SERVICE BULLETIN M20-319 Date: June 3, 2015

SUBJECT: Mooney M20TN - Revised Crankcase Breather Tube Installation

MODELS/ SN AFFECTED: Mooney M20TN 31-0001 thru 31-0127

Figure SB M20-319-1 - OLD-STYLE CRANKCASE BREATHER TUBE ASSEMBLY

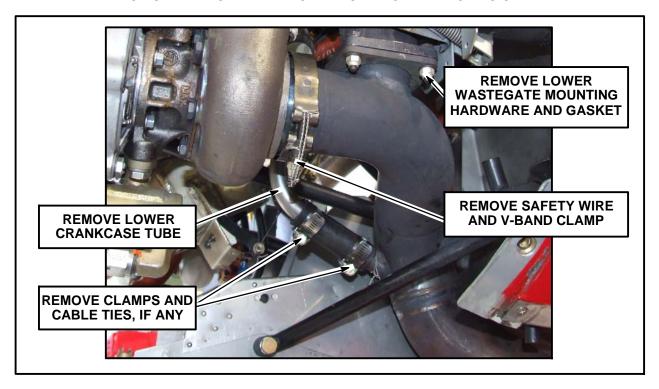
- **1.2.** Remove top and bottom cowling per instructions provided in Chapter 71-10-00 of applicable Mooney aircraft Service & Maintenance Manual.
- **1.3.** Remove clamps and cable ties, if used, from lower crankcase hose and breather tube. Remove crankcase hose. (See Figure M20-319-1)

- **1.4.** Remove assembly. (See Figure M20-319-1)
 - **a.)** Remove lower wastegate mounting hardware and gasket.
 - **b.)** Remove safety wire and exhaust V-Band clamp attaching left hand tailpipe to turbocharger.
 - **c.)** Remove and discard left hand tailpipe assembly or perform optional welding per Figure M20-319-3.

Figure SB M20-319-2 - AIR-OIL SEPARATOR, CRANKCASE TUBE, AND CLAMPS

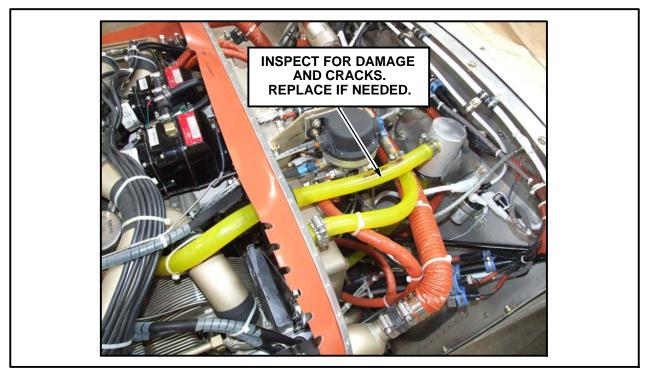
Inspect upper crankcase hose to verify it is free of damage and cracks. Replace if needed using new Tygon hose P/N 620072-1. (See Figure M20-319-2)

Figure SB M20-319-3 - LH TAILPIPE, WELDING EXISTING TAILPIPE

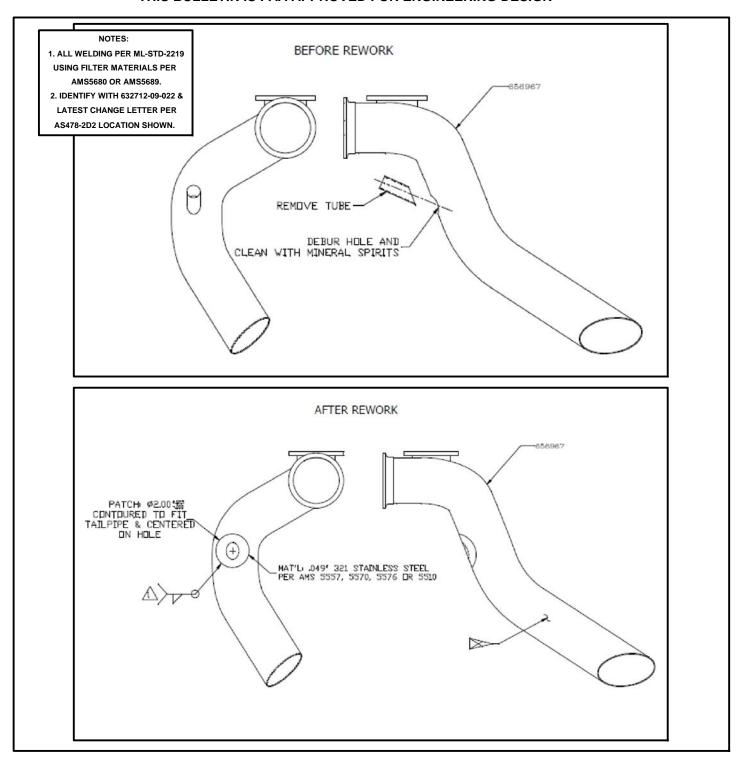
Welding repair must be performed by an FAA Certified Repair Station that possesses the capability to perform the repair per the specifications called out in Figure M20-319-3. The repaired tailpipe must be delivered with a valid FAA Form 8130-3.

- **b.)** Attach clamps using mounting hardware AN3-4A bolt, NAS1149F0332P washers, and MS21045L3 nut.
- **1.7.** Install new left hand tailpipe P/N 658428 (See Figure M20-319-6) or repaired tailpipe per Figure M20-319-3.

Figure SB M20-319-4 - LH TAILPIPE, LOWER WASTEGATE MOUNTING HARDWARE, AND V-BAND CLAMP INSTALLATION

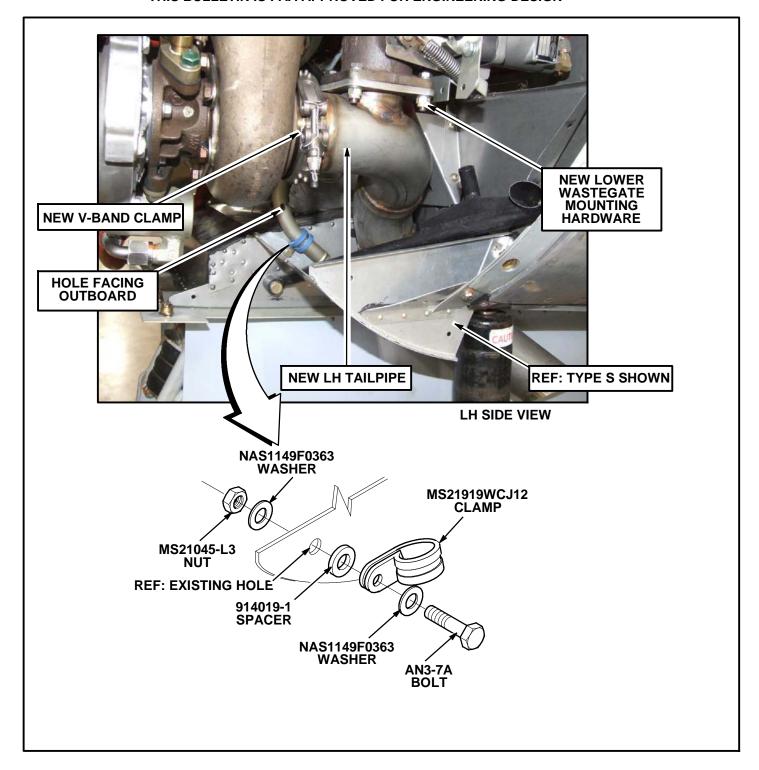
- **1.5.** Install new tubing.
 - a.) Install new breather tube P/N 620071-5 on lower exhaust cavity with clamp P/N MS21919WCJ12, AN3-7A bolt, (2) NAS1149F0363P washers, 914019-1 spacer, and MS21045L3 nut. Orient new breather tube with vent hole facing outboard as shown in Figure M20-319-4.
 - **b.)** Install new P/N 628555-45 hose (trim to fit) to lower air-oil separator connector and new breather tube with (2) clamps P/N 20010. (See Figure M20-319-5)

Figure SB M20-319-5 - LOWER CRANKCASE HOSE INSTALLATION

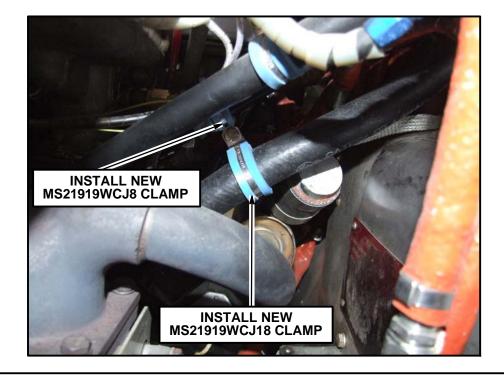
- **1.6.** Install new P/N MS21919WCJ18 cushion clamp to P/N 628555-45 hose. (See Figure M20-319-5)
 - a.) Install new P/N MS21919WCJ8 cushion clamp to engine mount.

Figure SB M20-319-6 - LOWER WASTEGATE AND TAILPIPE INSTALLATION

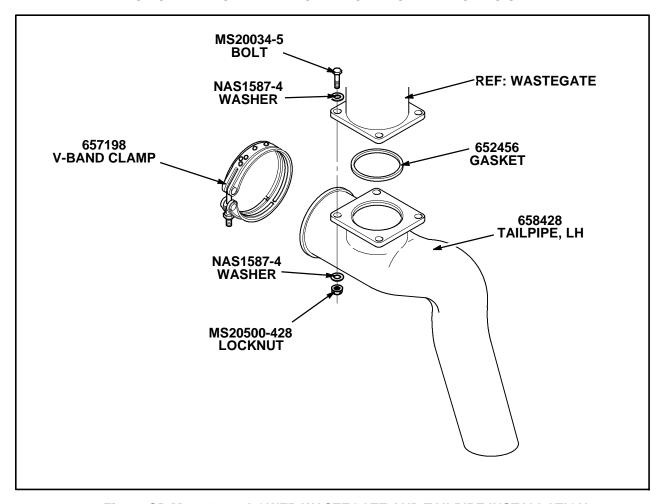
- **a.)** Install new wastegate gasket and new lower wastegate mounting hardware. Do not torque, but leave allowable movement for tailpipe V-Band clamp to be installed.

- b.) Install new exhaust V-Band clamp P/N 657198. Torque evenly per instructions provided in Chapter 81-30-00 of the M20TN aircraft Service & Maintenance Manual. Also refer to instructions provided in Chapter 17 of the applicable Continental Motors Engine Maintenance & Overhaul Manual. Torque V-Band clamp to 35-40 in lbs. Strike outer periphery of coupling band lightly to distribute load. Tighten to net torque of 50-60 in lbs plus nut running torque. Torque wastegate mounting hardware to 200-210 in lbs.
